City of Lone Tree Planning Commission Agenda Tuesday, December 9, 2014

SUBJECT: Sky Ridge TOD Subarea Plan
Project File #SA14-72R

Sky Ridge Station Transit Oriented Development Sub-Area Plan

Re: RTD Referral Comments; SkyRidge TOD Subarea Plan

Exhibit 6.0: Public Transportation Framework Plan

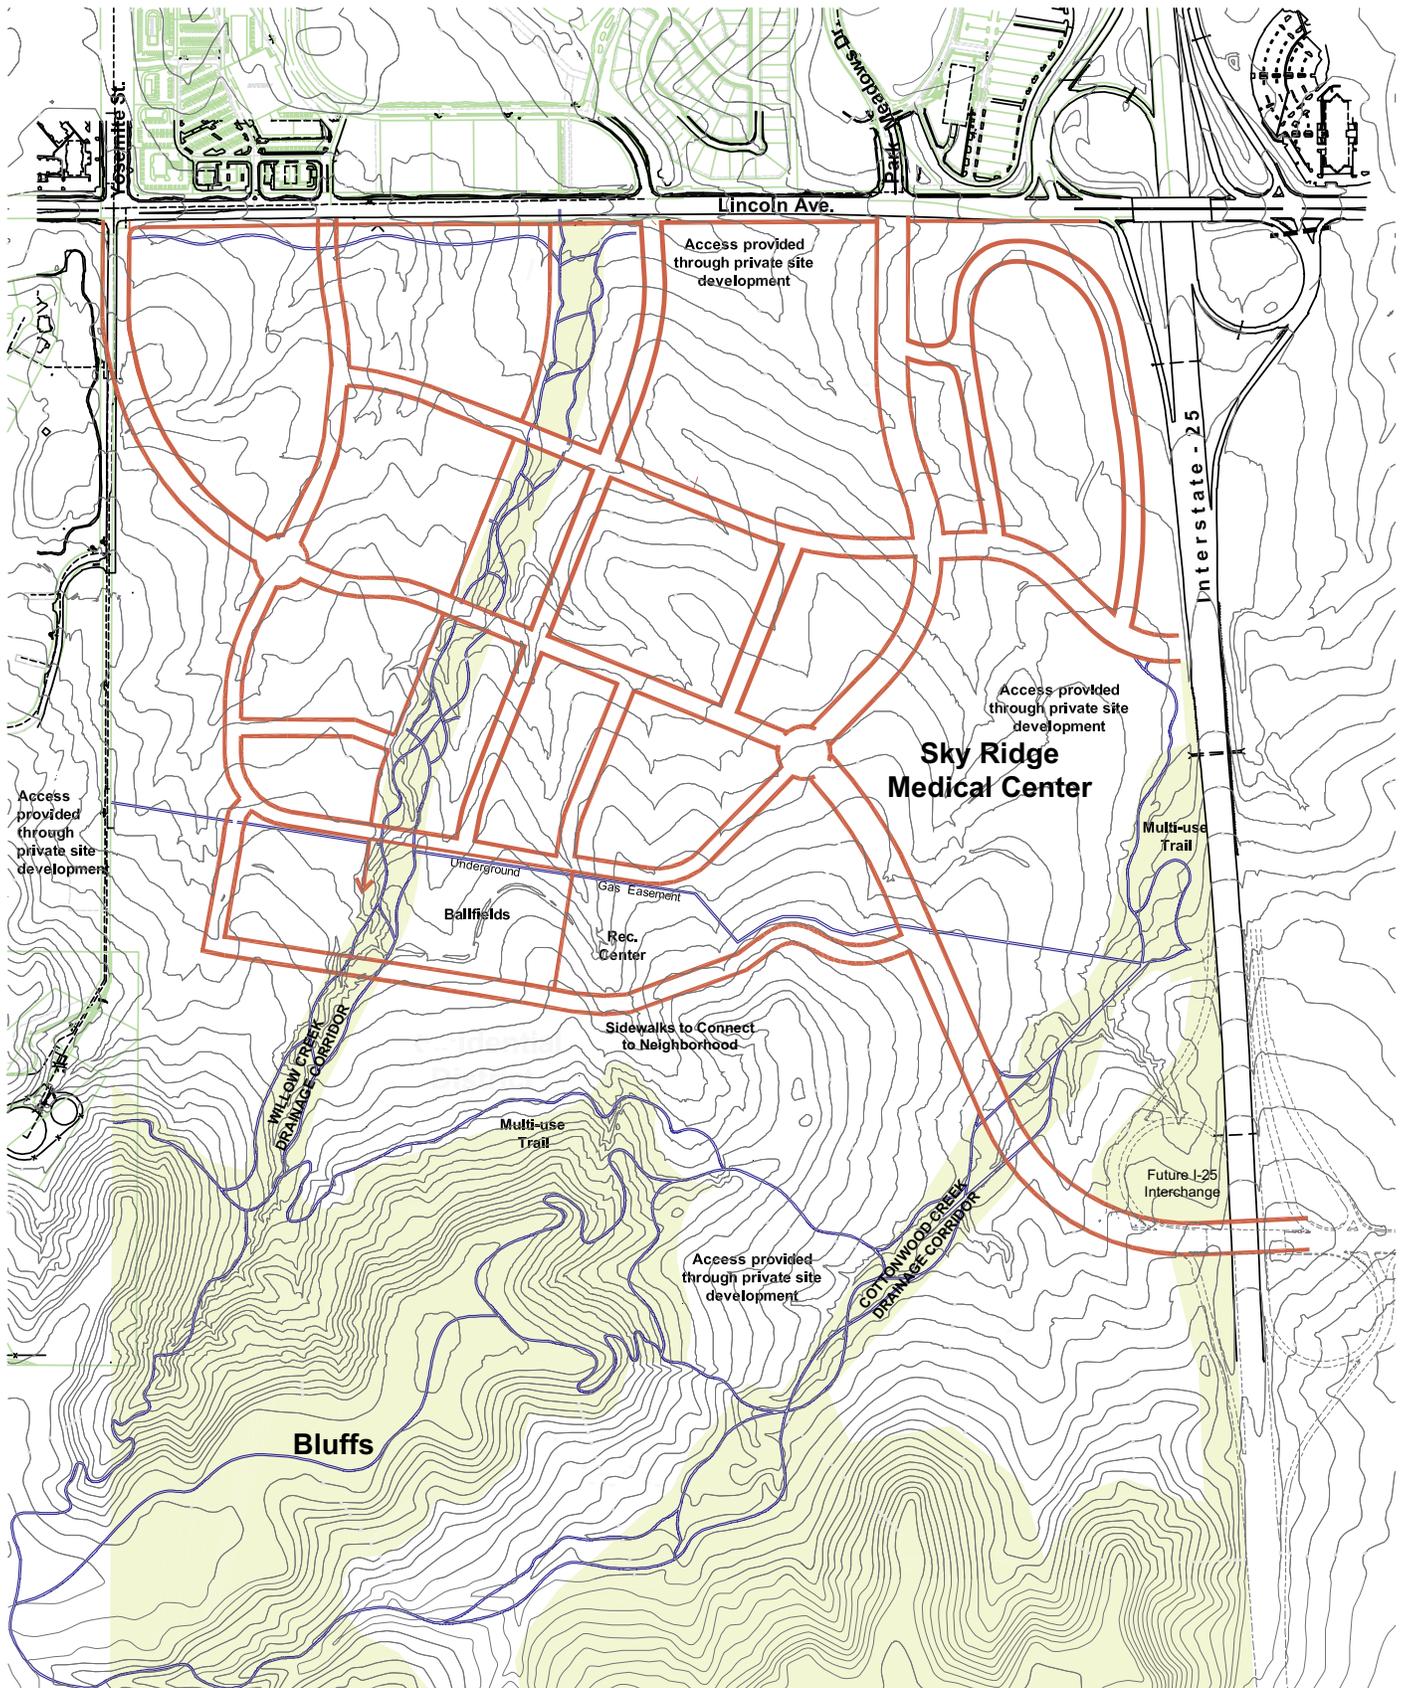
1. Exhibit 6.0; Public Transportation Framework Plan
 - Bus Route Terminology
 - RTD service that will be provided to the SkyRidge subarea would likely be designated as Local, rather than Regional, and the fare structure corresponds to the service. Therefore, to avoid confusion, RTD suggests using the term, 'Future RTD Local Bus Route' or just 'Future RTD bus route' for the route shown in red and 'Loop Bus Service (or Shuttle)' for the service shown in light purple. This will also help to distinguish RTD-provided service from developer or City-provided service.

- The RTD route shown in red utilizes Park Meadows Boulevard north across Lincoln Avenue. It is more likely that future RTD routes in this area would use RidgeGate Parkway east across I-25. However, the explanation included in the exhibit, which is that the framework is conceptual and will be refined, is noted.
